Ref: 17165-Waitara-BCAReportR3-201217R2

WAITARA PUBLIC SCHOOL

**BUILDING CODE OF AUSTRALIA 2016
FINAL DA STAGE REVIEW**

DECEMBER 2017

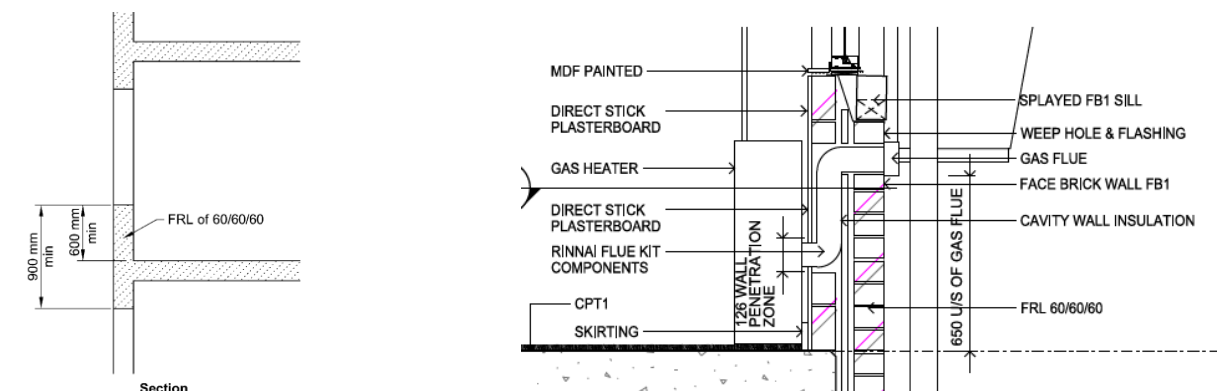
The vertical spandrel panels beneath the windows in the building should be very clearly identified on the final design drawings and they should be stated to have an FRL of at least 60/60/60.

The horizontal spandrel panels in the building should be very clearly identified on the final design drawings and they should be stated to have an FRL of at least 60/60/60.

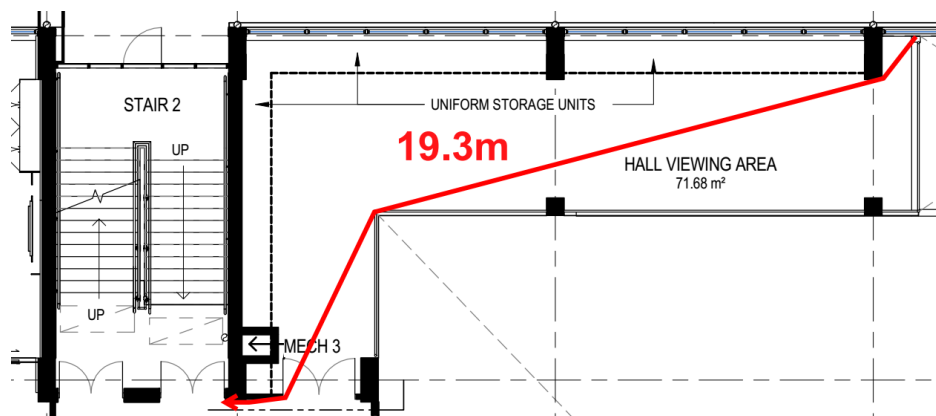
The travel distance from the corner of the homebase 30 on level 4 will have to be reassessed after the furniture plans are provided for review to ensure that the point of choice is within 20m of the starting point. It is expected that egress will be provided from level 3 through the foyer and into the adjoining building.

Please ensure that the hall viewing area on level 2 is not provided with furniture as it may extend the travel distance to the exit to more than the maximum permitted distance of 20m.

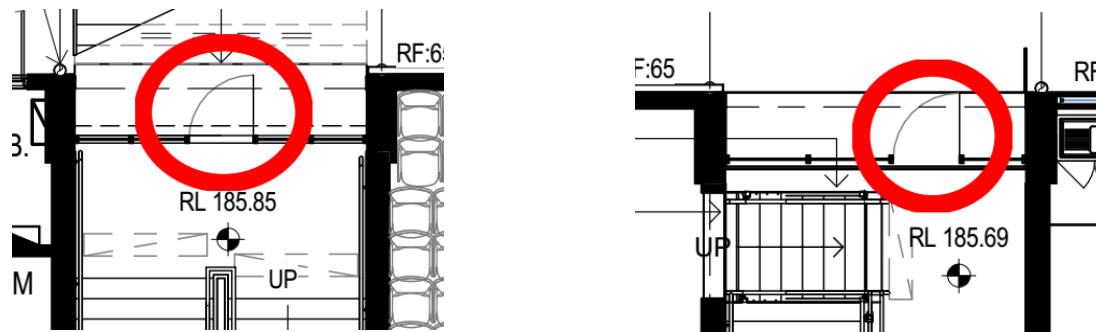
The population of level 3 and 4 is taken to be 400 people on each floor (25 staff and students per classroom x 16 per floor) and therefore the required aggregate exit width on each floor is 4m ie:

- 1.34m of required exit width for each of the stairs. (Each door to be at least 750mm clear.)

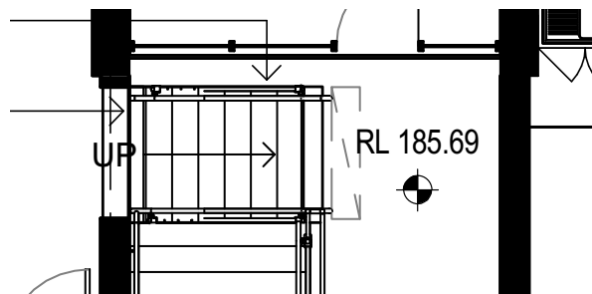
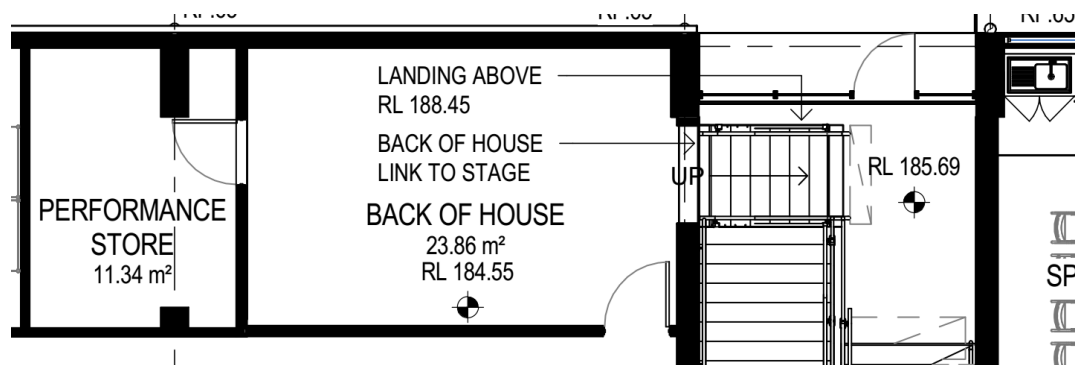
The opening into the level 1 fire stair at grid 8 is not permitted by the BCA and is required to be addressed in a fire engineered performance solution.

In addition, the opening into the fire stair is required to be provided with a fire door. The door that separates the stage from the back of house and the performance store from the back of house should not be used as the fire stair doors as there will likely be too much combustible goods in the back of house room and it should not form part of the fire stair.

Any door provided should incorporate the required 7500mm minimum long top landing to the stair.

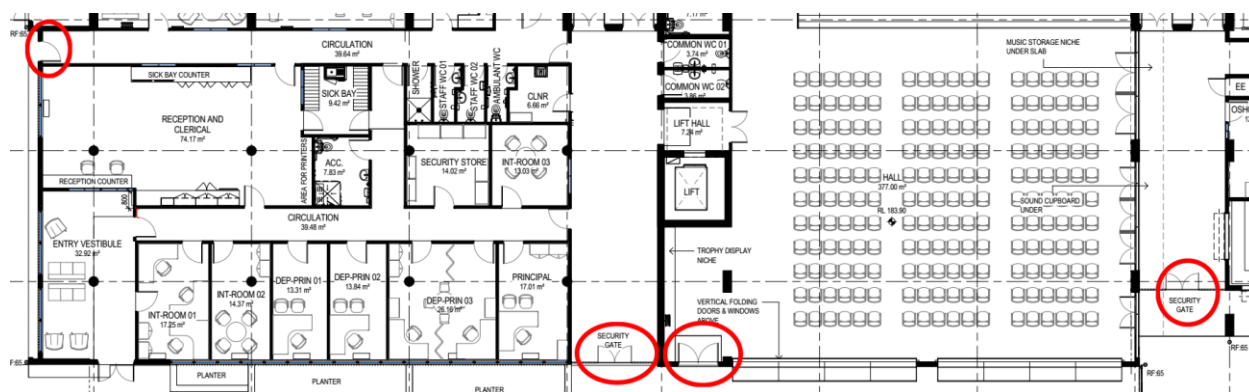
Wall elevations should be coordinated with the services documentation to ensure compliance with this requirement.

This applies to windows on level 03 and 04 if they are operable. If the cill heights to operable windows are less than 865mm the windows will need to be restricted to a maximum opening size of 125mm (100mm recommended).
